ADDENDUM

04PR0391

Smith Packett Med-Com, Inc (The Crossings at Bon Air)

<u>REQUEST</u>: Site plan approval of an adjustment to a site plan previously approved through administrative review.

REVISED INDEPENDENT LIVING& ASSISTED LIVING BUILDING (SIZE REDUCED WITH MINOR CHANGES TO PARKING LAYOUT)

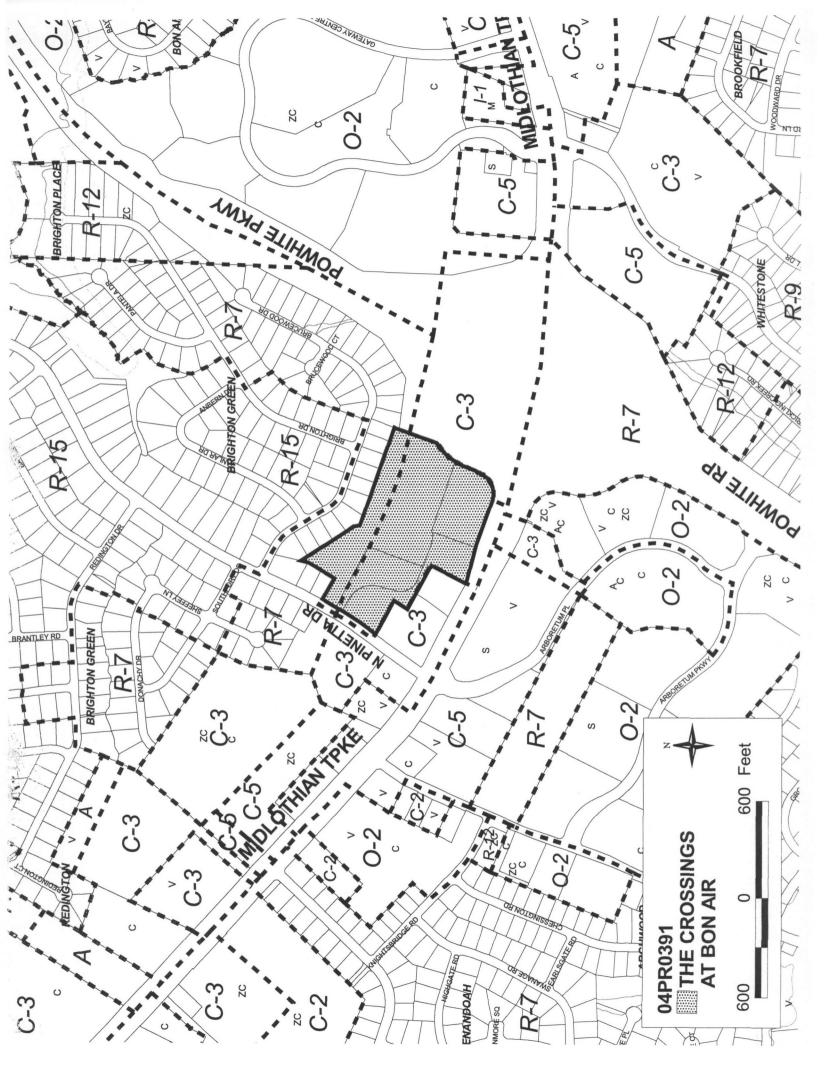
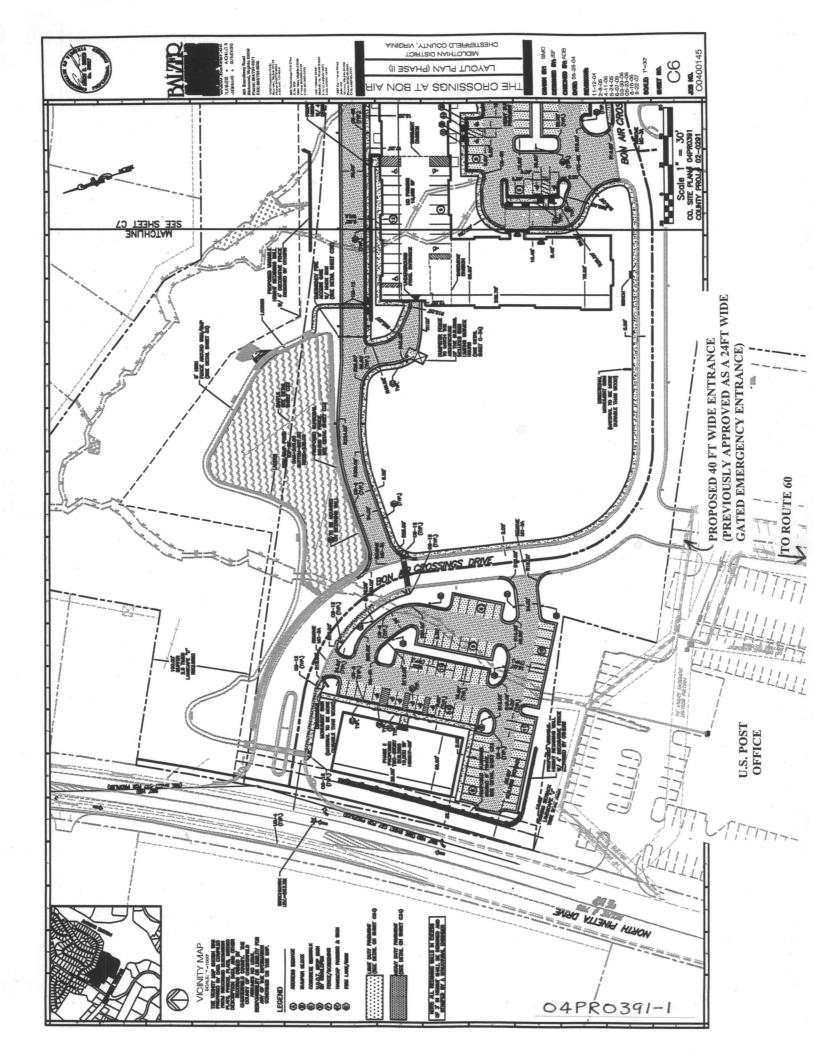
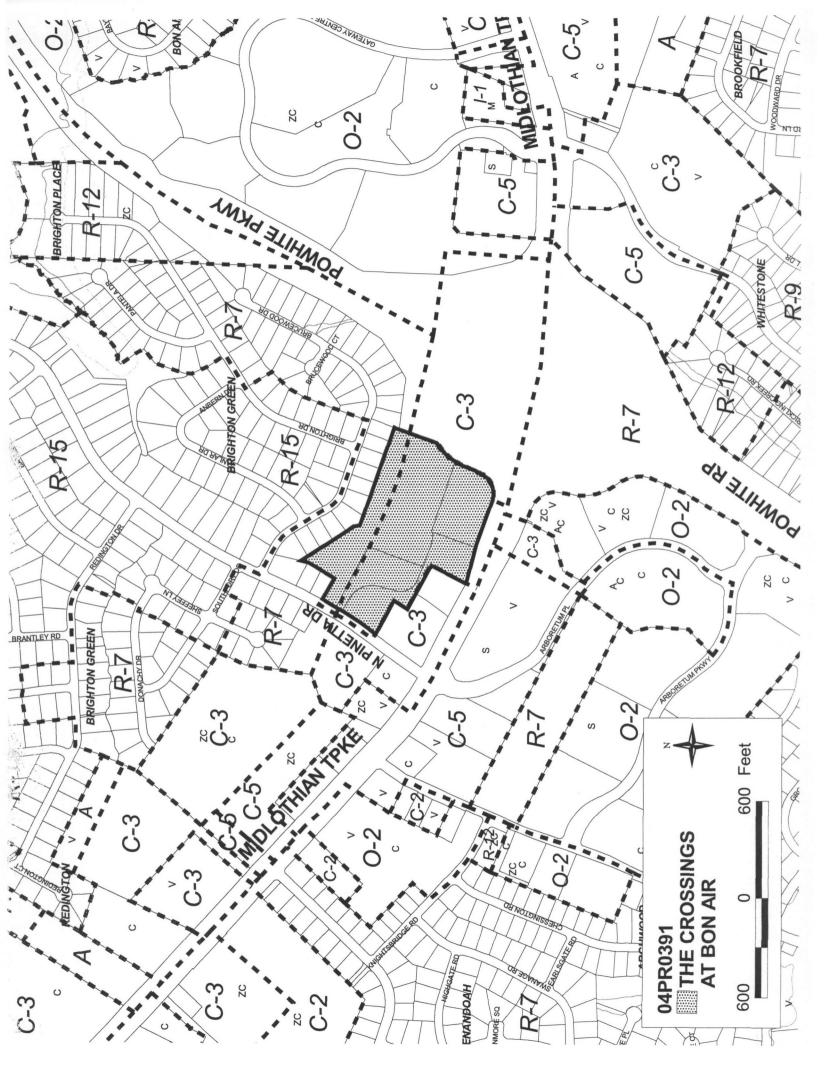
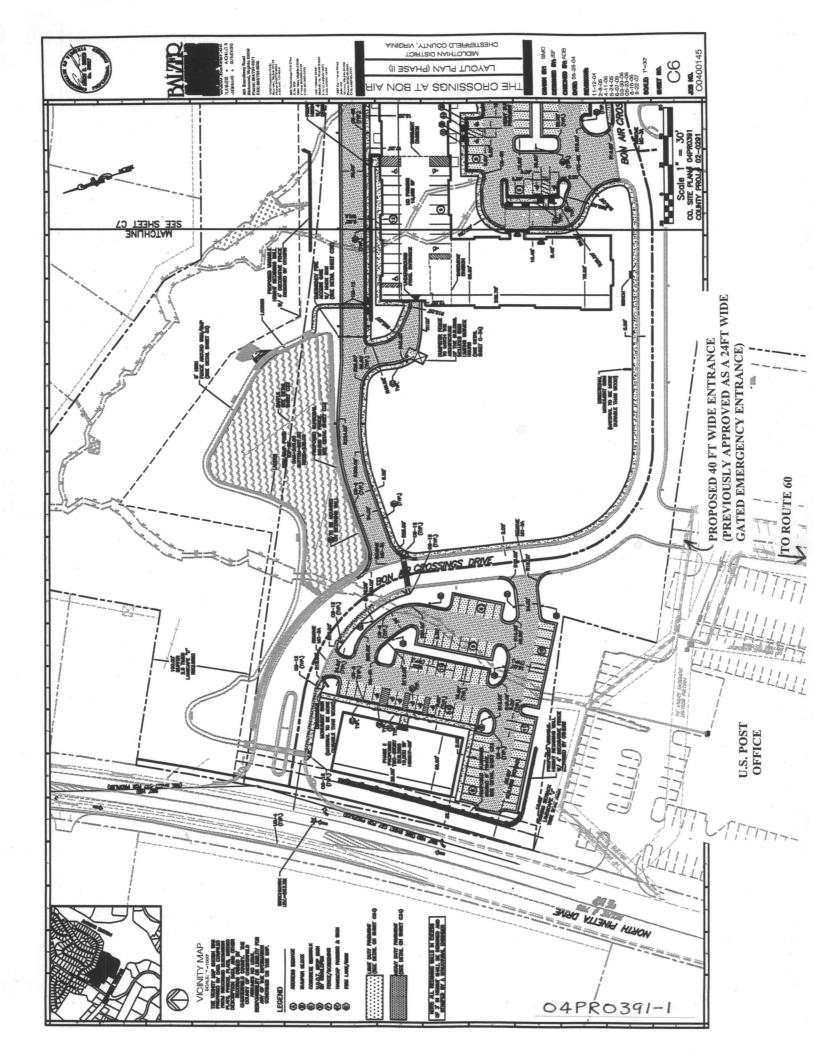
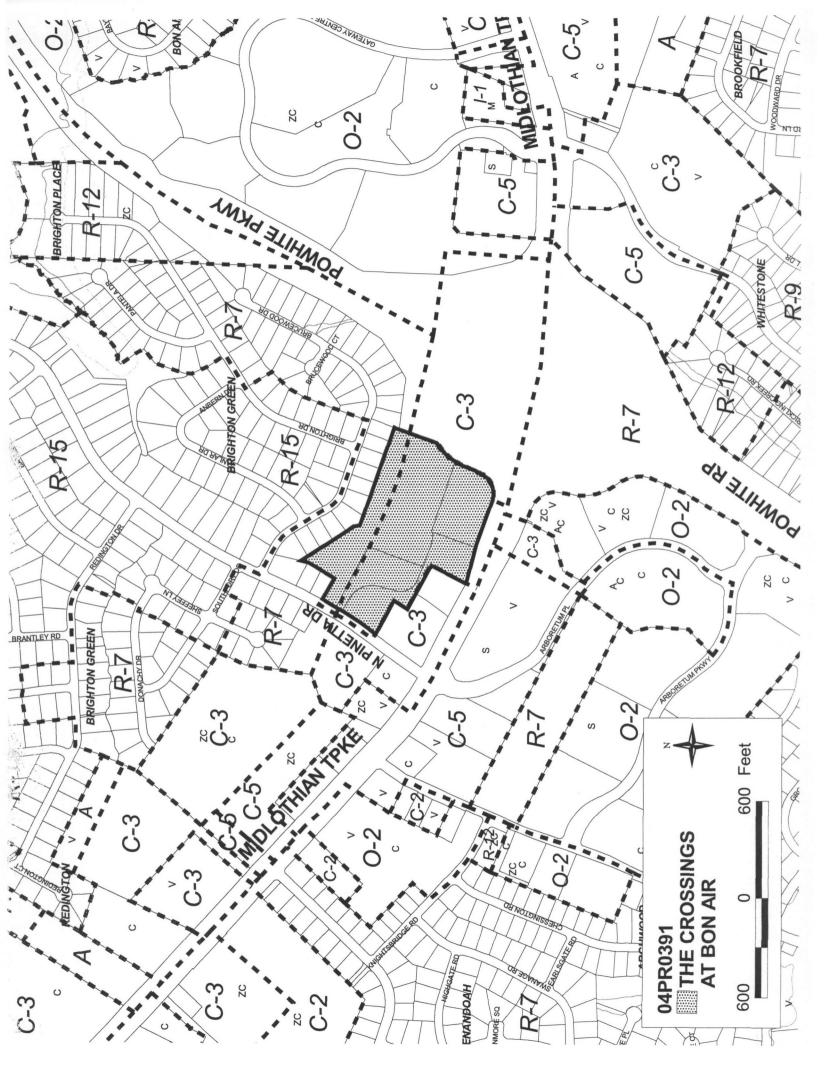
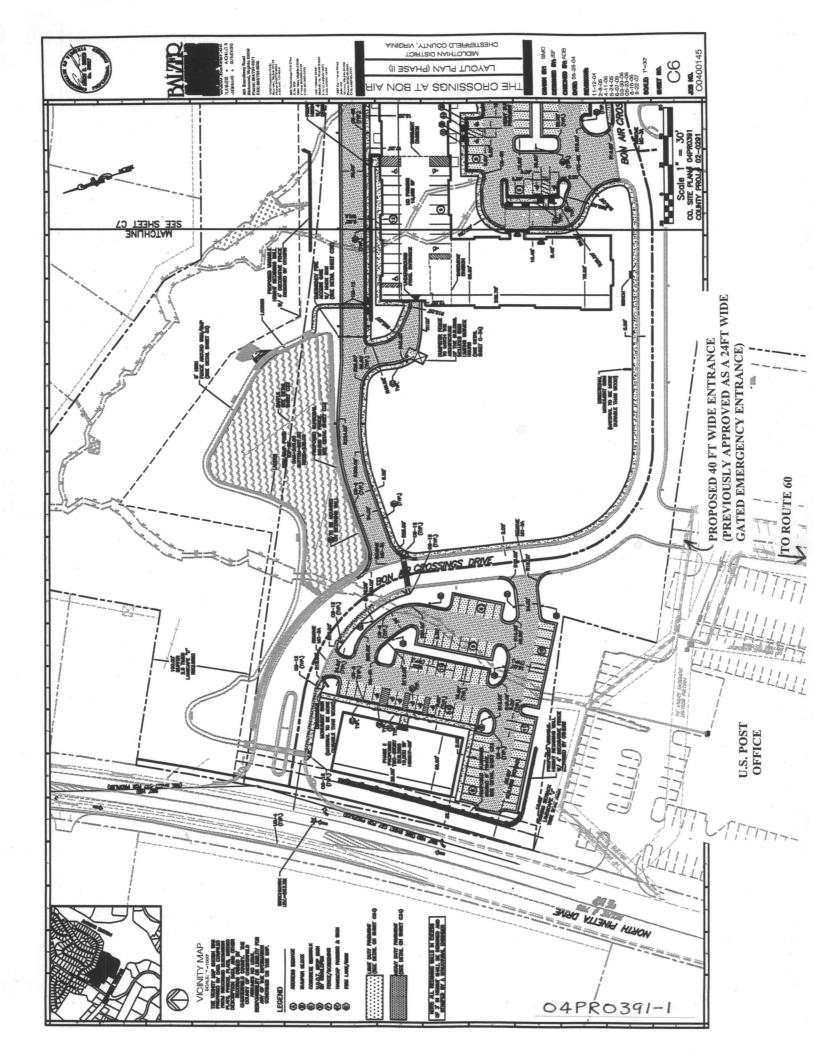
- 1. VDOT cannot support this proposed increased usage of the Route 60 entrance, due to operational and safety concerns raised by the proximity of the access to the Powhite Parkway off-ramp and to the signalized intersection of Route 60 and Pinetta Road. The original intent in allowing the site to connect to the driveway was to provide only emergency service to the site to reduce these problems. (VDOT)

- 2. The change in use of the entrance and the increase in traffic at the entrance introduce the need to meet minimum VDOT standards, which are not currently met. The separation between entrance and intersection is less than the required length of 400 feet, to allow full right turn lane to the intersection. The site's projected traffic may also create the need for a separate right turn lane into the Route 60 site entrance. (VDOT)

- 3. The developer shall submit a traffic study for VDOT review and approval showing the entrance can operate as proposed without causing interference to the Powhite Parkway movements or to normal intersection operations. The study should include the projected site traffic expected to utilize the entrance, a merging/diverging analysis at the ramp area to the intersection, an accident analysis within the area and a right turn lane analysis into the site. Unless the approved study shows the entrance can operate successfully, VDOT cannot support unrestricted access. (VDOT)

- 9. The access to Route 60 must be gated to permit emergency vehicles only. (T)
- 10. Gate detail is shown on plan, however the placement location of the gate needs to be marked on plan. (F)

EXHIBIT B

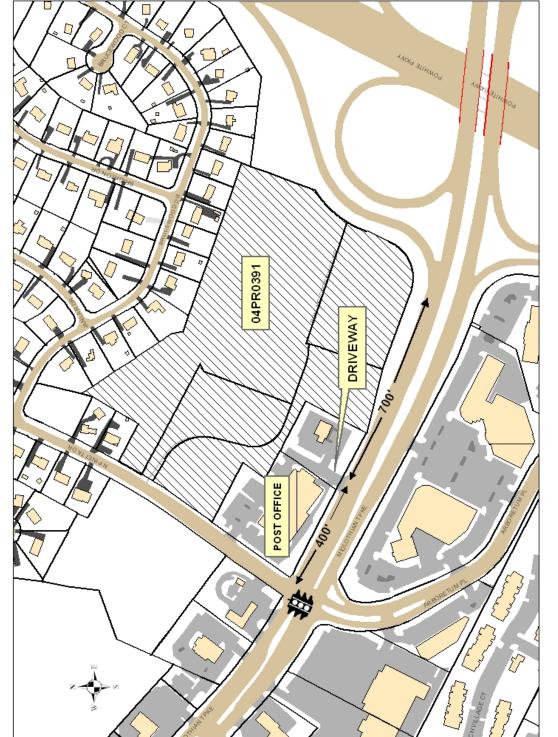
The driveway is located only 700 feet from the southbound Powhite Parkway exit ramp. Westbound traffic stopped at the traffic signal at Pinetta Drive routinely queues beyond this access (Exhibit B). Traffic from Powhite Parkway has extreme difficulty weaving over into the through lane on Route 60 due to this queued traffic. During peak hours, traffic using the driveway to exit the property will experience long delays as they wait for a break in the traffic stream on Route 60. Drivers could become impatient, leading them to take risks that they would not normally take.
